UNITED STATES PATENT AND TRADEMARK OFFICE

APPLICATION NO.	FILING DATE	FIRST NAMED INVENTOR	ATTORNEY DOCKET NO.	CONFIRMATION NO.
10/531,334	08/23/2005	Edeltraud Hagemeister	PAT-01078	7934

Office Action Summary	Application No. 10/531,334	Applicant(s) HAGEMEISTER ET AL.	
	Examiner WILLIAM K. CHEUNG	Art Unit 1796

DETAILED ACTION

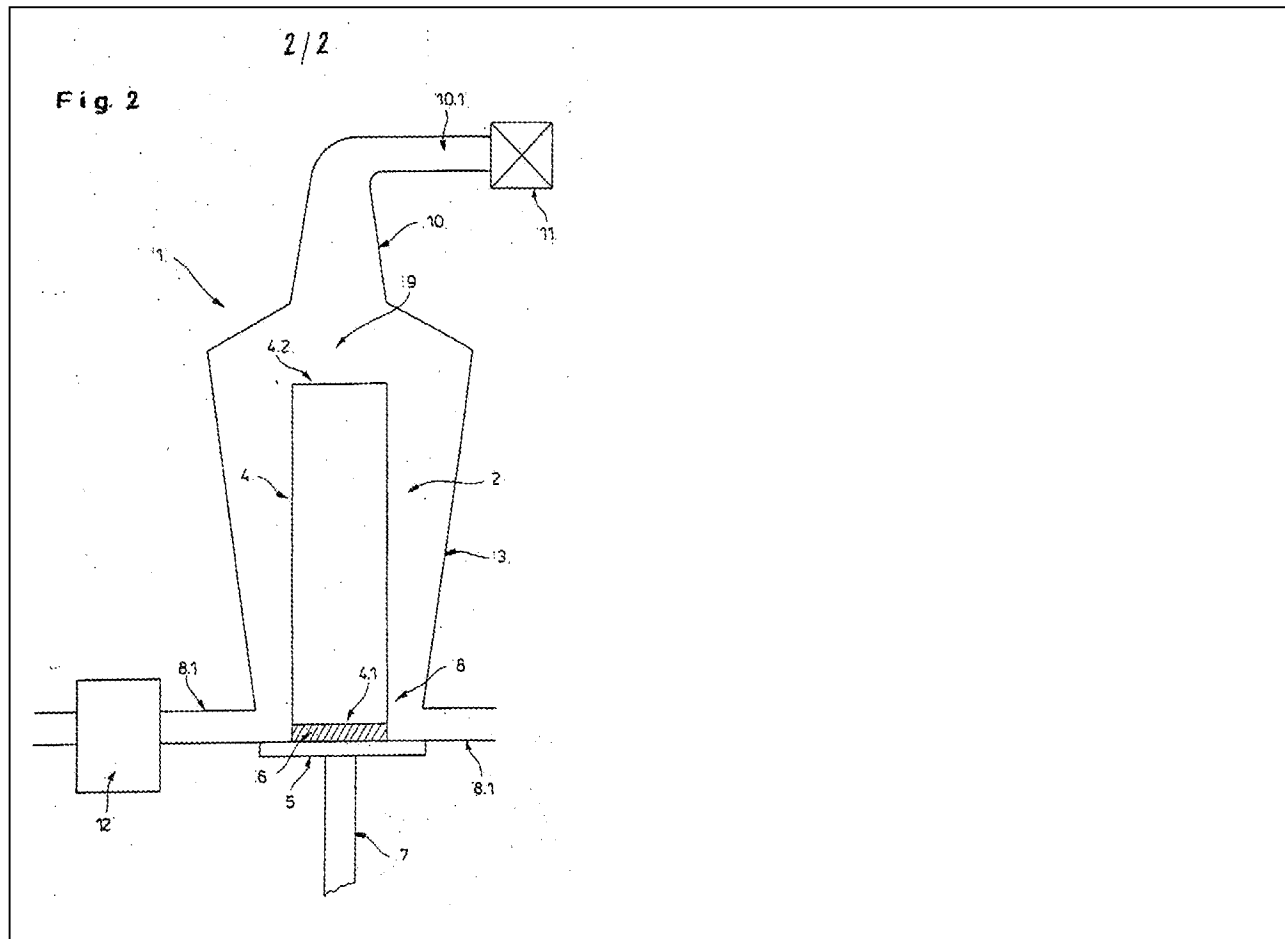
3. Claims 1-19 are provisionally rejected on the ground of nonstatutory obviousness-type double patenting as being unpatentable over claims 10-24 of copending Application No. 10/549,624. Although the conflicting claims are not identical, they are not patentably distinct from each other because the apparatus as claimed

seems to be able to perform the functions of the apparatus of claims 10-24 of copending Application No. 10/549,624, particularly in light of Figure 2 of copending Application No. 10/549,624.

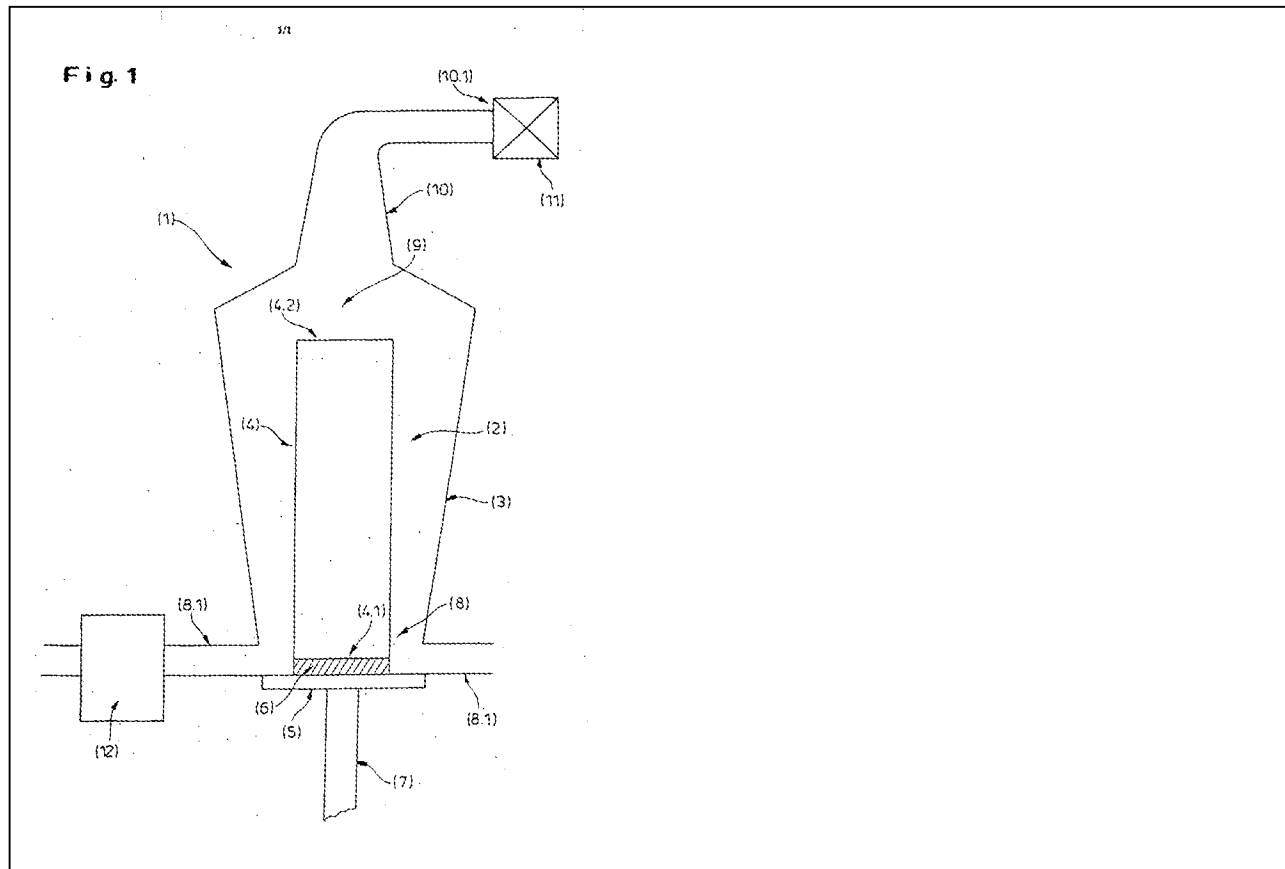
4. Claims 1-19 are provisionally rejected on the ground of nonstatutory obviousness-type double patenting as being unpatentable over claims 1-11 of copending Application No. 10/486,893. Although the conflicting claims are not identical,

they are not patentably distinct from each other because the apparatus as claimed seems to be able to perform the functions of the apparatus of 1-11 of copending Application No. 10/486,893, particularly in light of Figure 1 of copending Application No. 10/486,893.
